ADDENDUM

ADDENDUM NO.: 02
PROJECT NAME: Sherman Park Branch Library – Repairs and Renovations
PROJECT NO.: 08325
CONTRACT NO.: C1630
DATE OF ISSUE: July 28, 2026

NOTICE OF CHANGES, MODIFICATIONS, OR CLARIFICATIONS TO CONTRACT DOCUMENTS

Sheet
P1.01

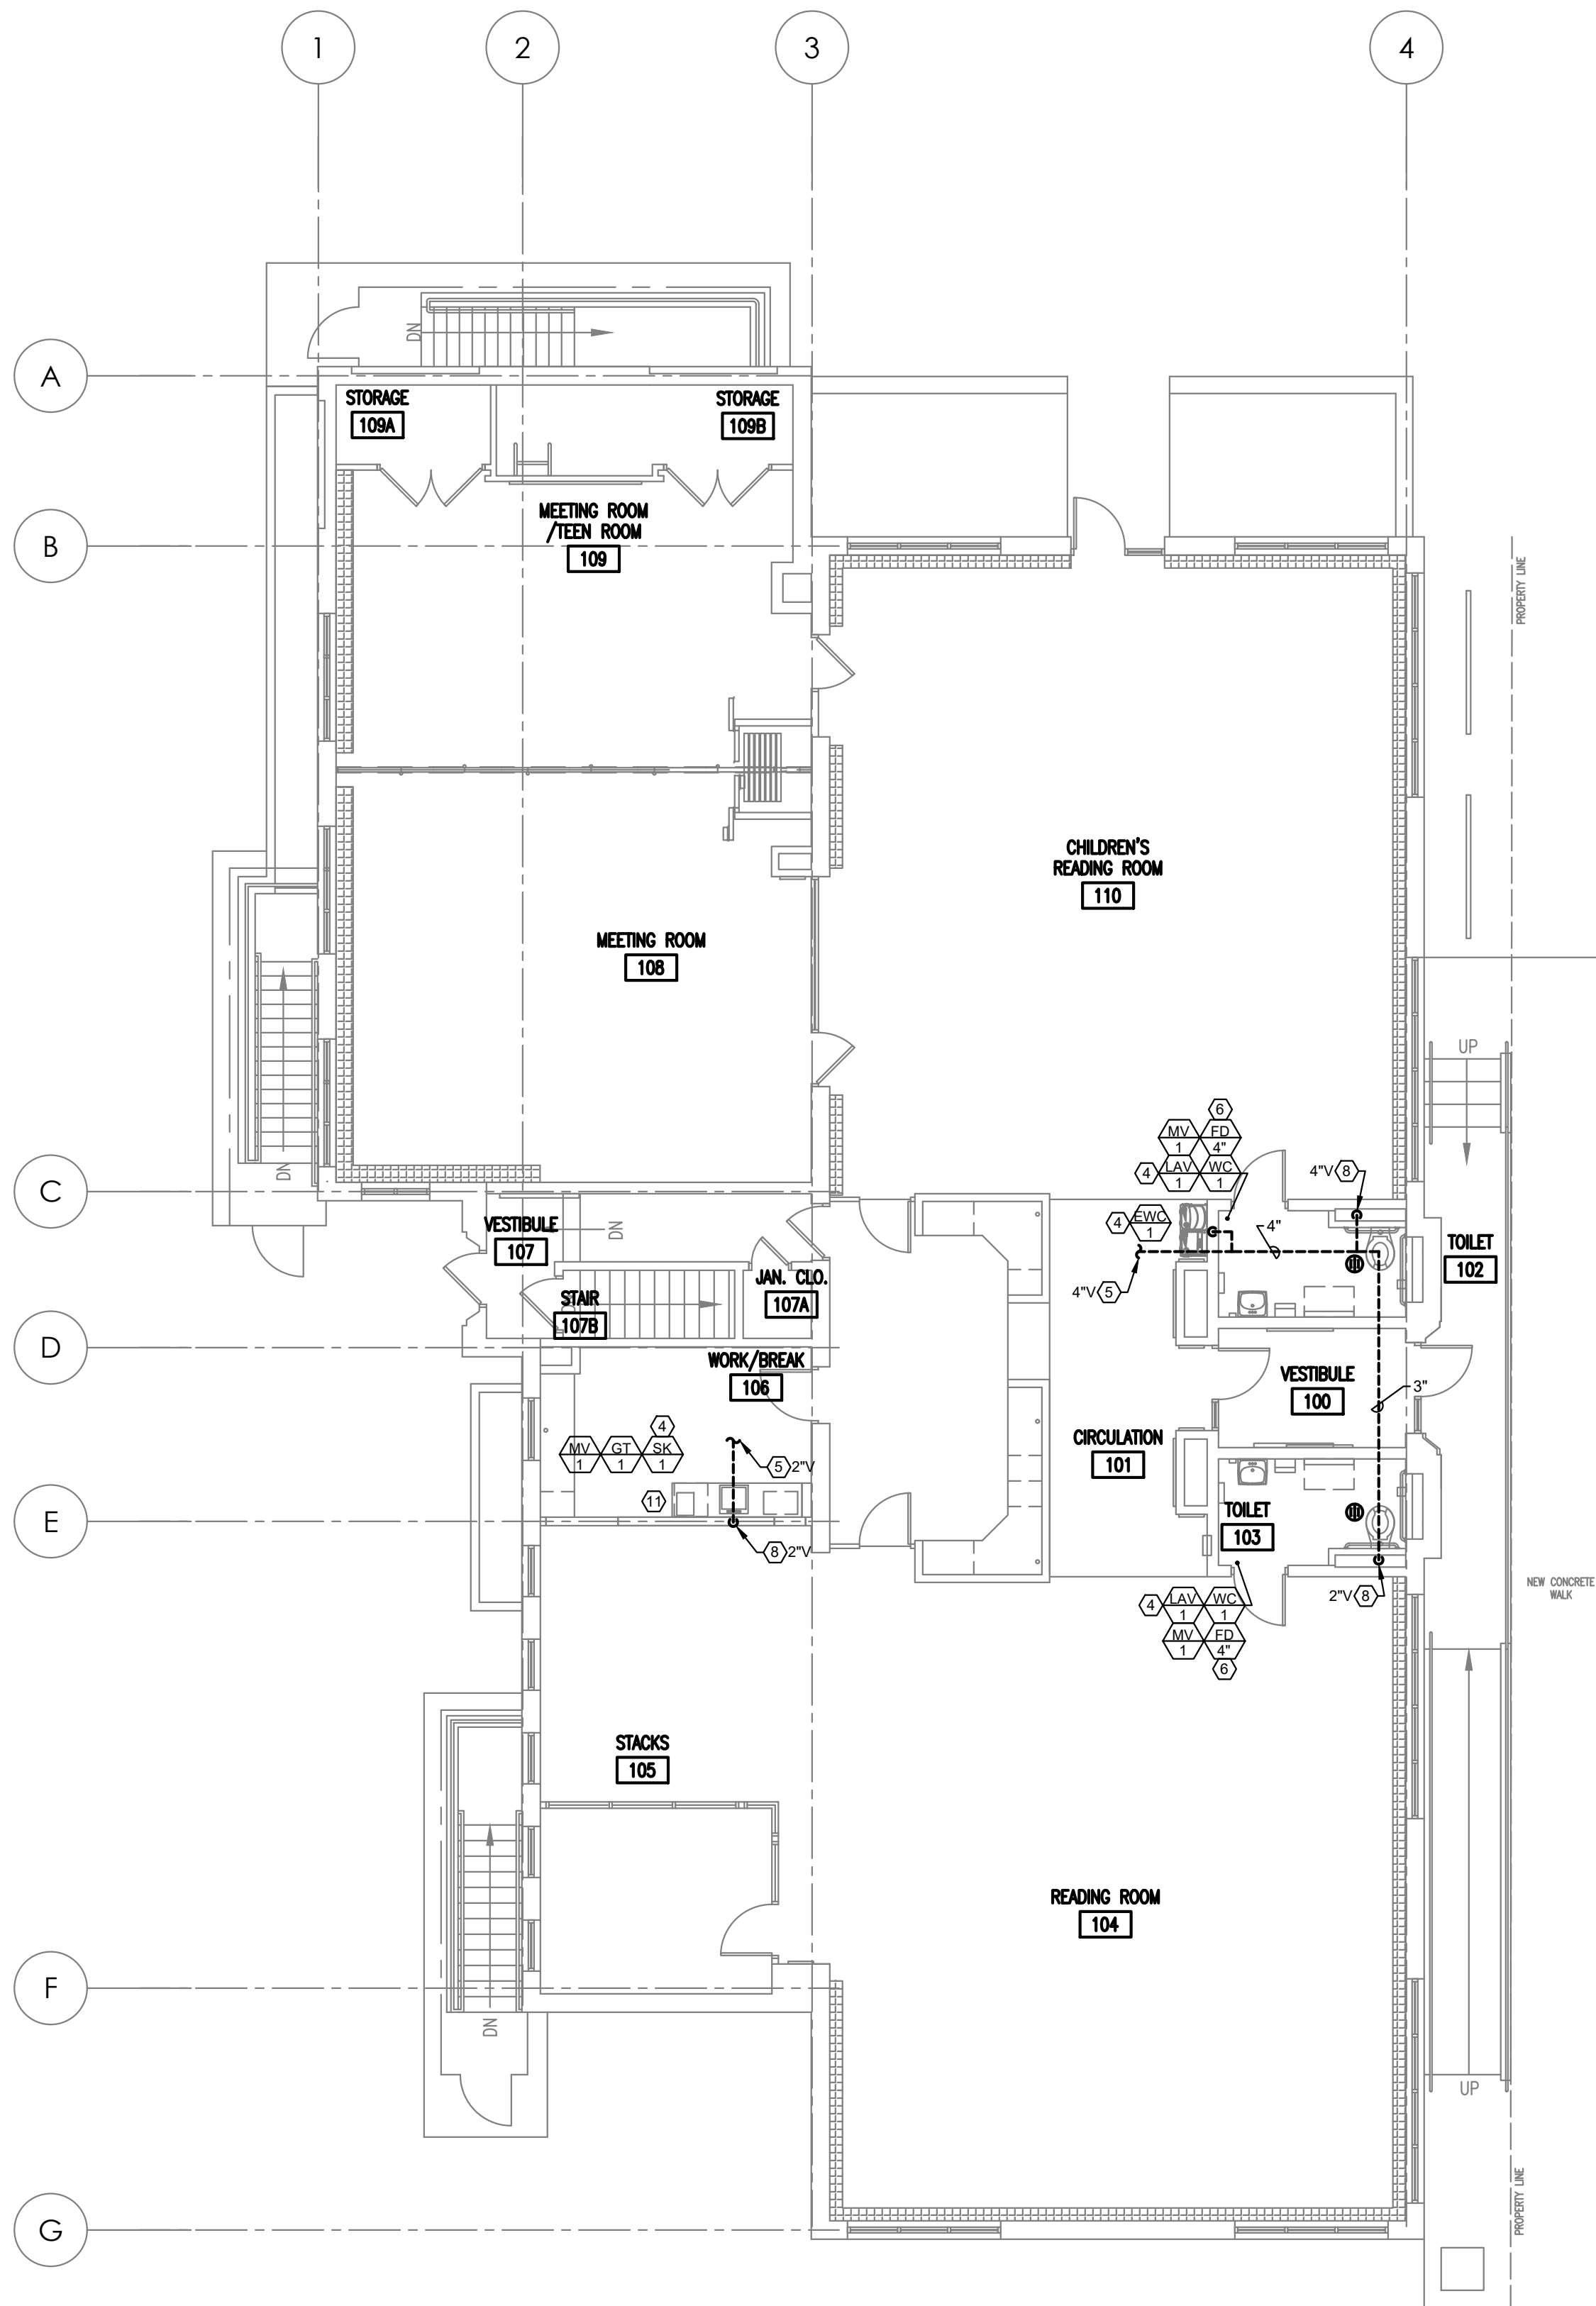
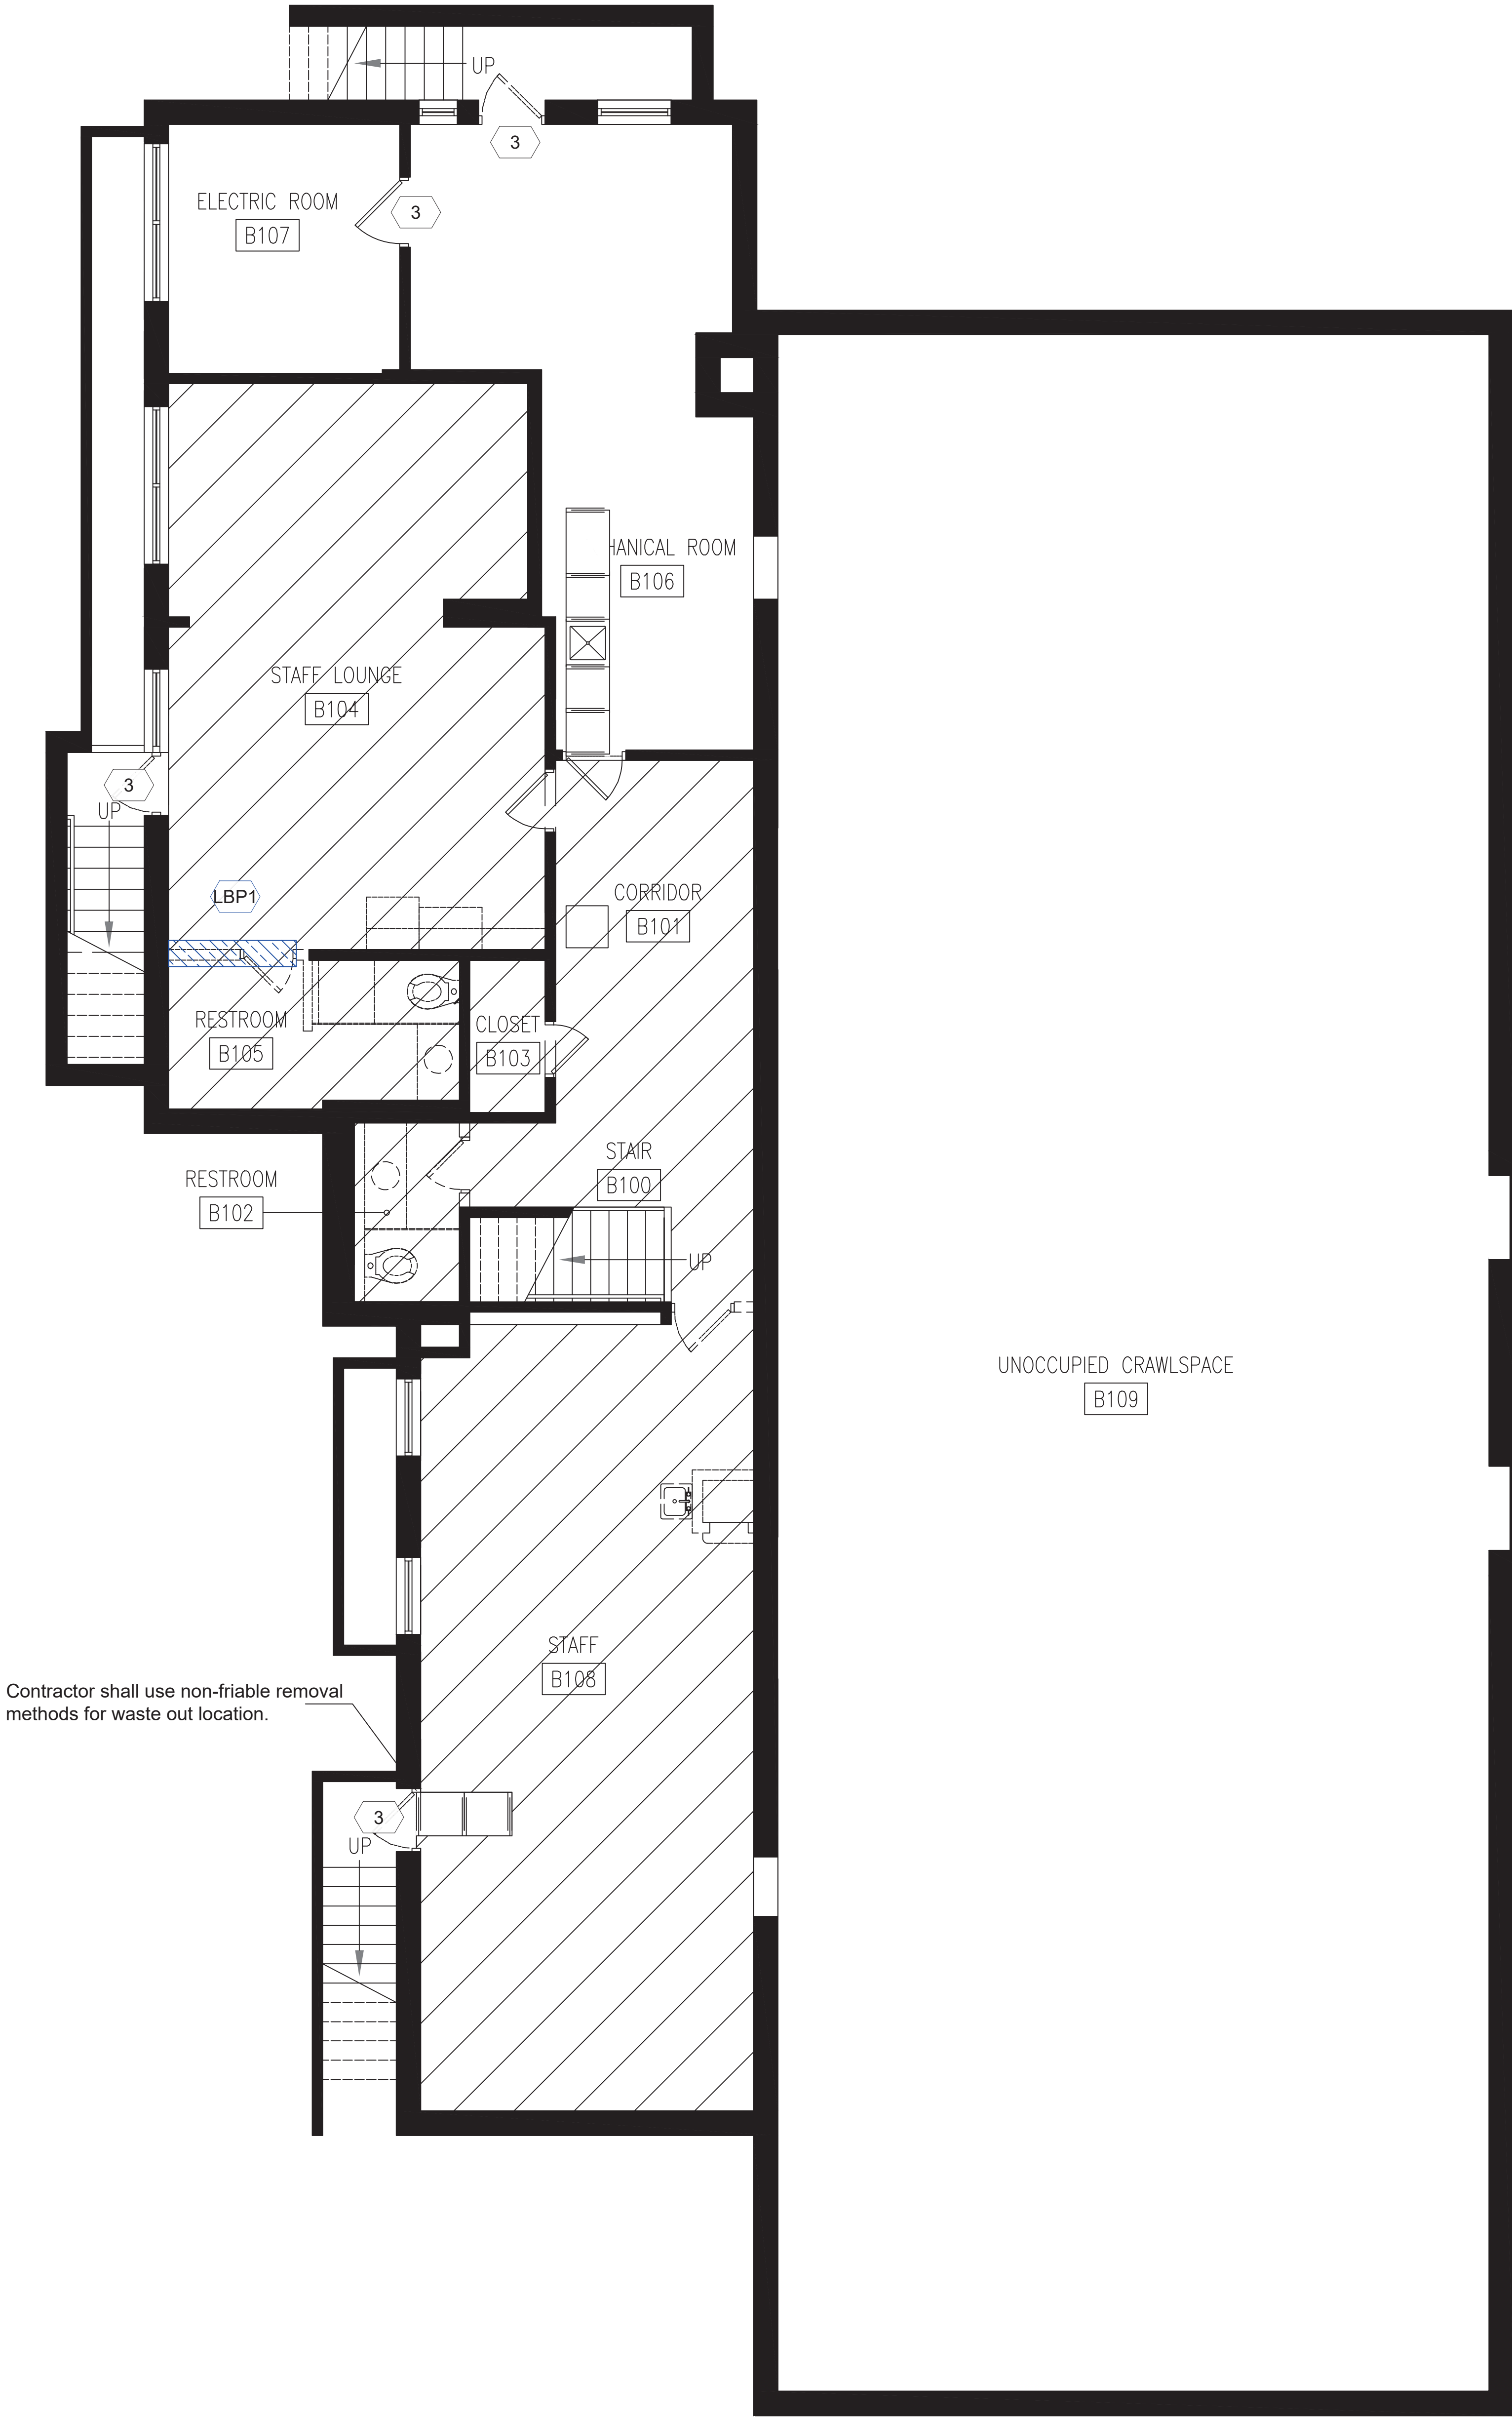
Change 4 REVISED General Notes P1.01: Deleted third bullet point.

- NOT USED
- DRAWINGS SHOW EXISTING CONDITIONS IN DIAGRAMMATIC FORM. EXTENT OF SYSTEMS, SIZES, LOCATIONS AND CONDITIONS ARE TO BE VERIFIED IN THE FIELD.

Sheet NOT FOR CONSTRUCTION
ENV1.2

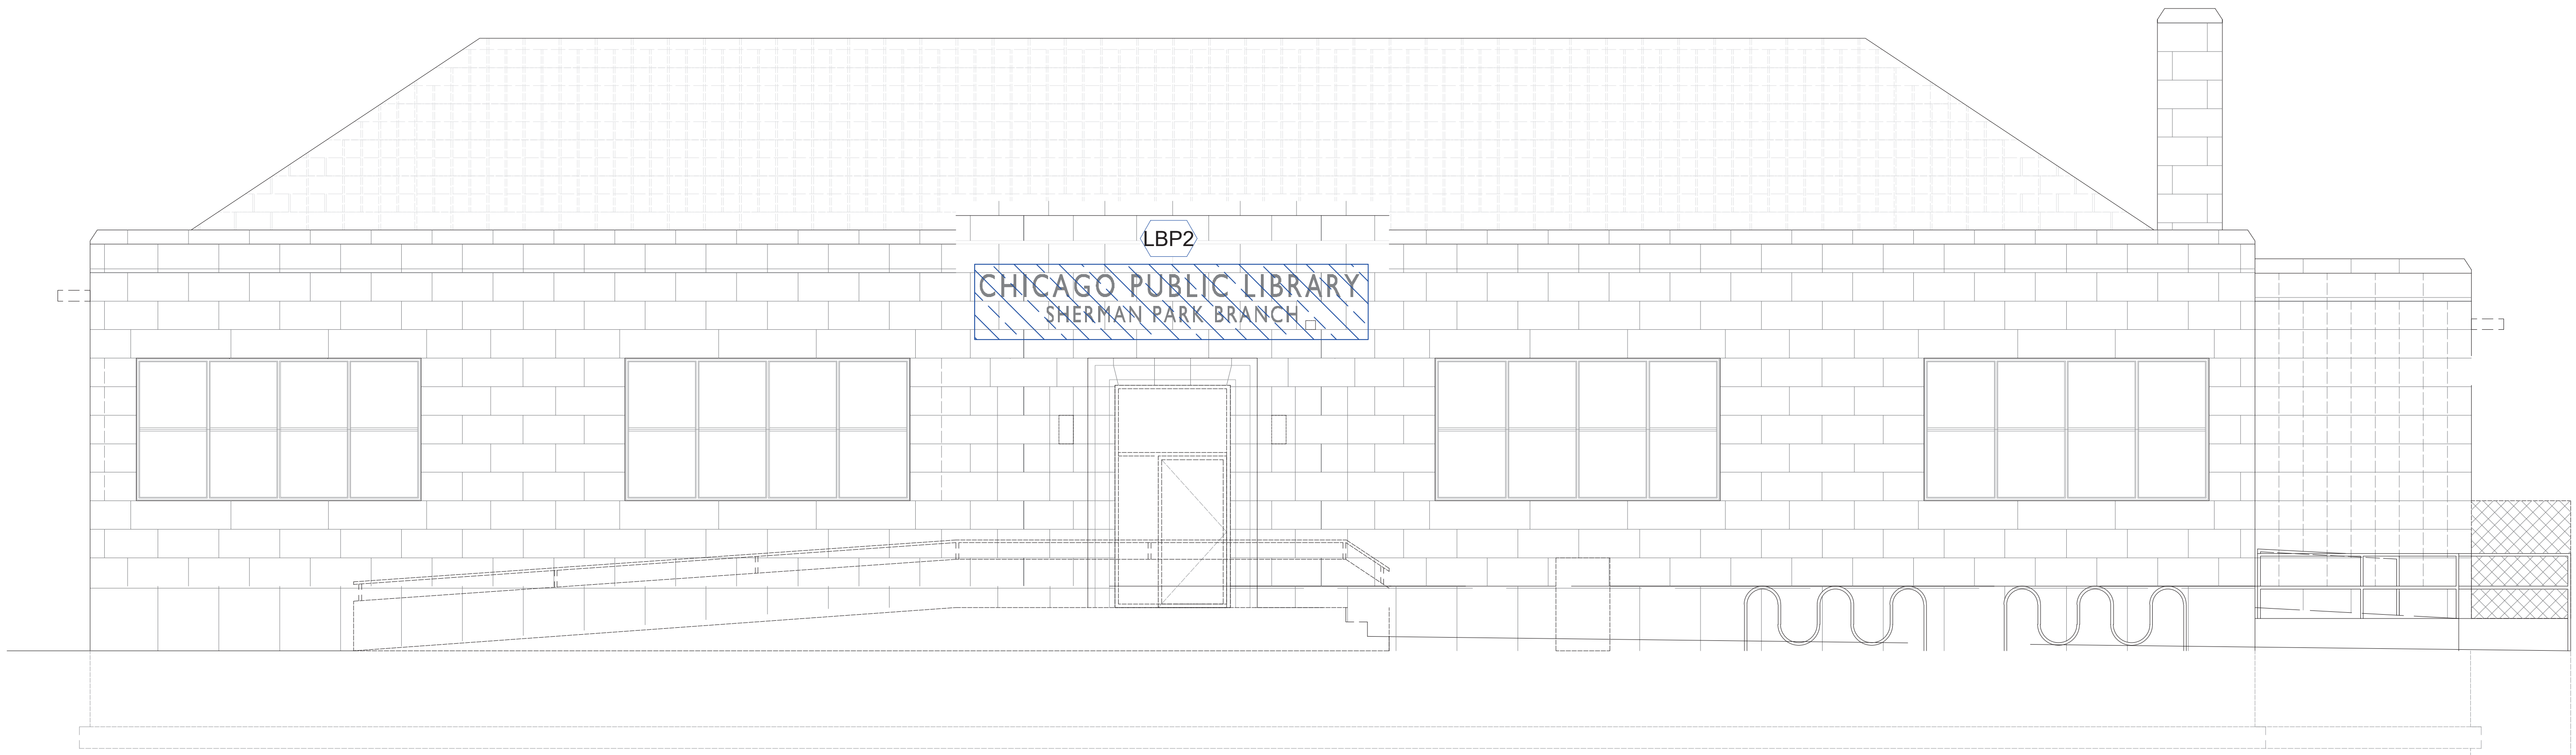
Change 7 Revised Drawing ENV 1.2: Deleted note number seven.
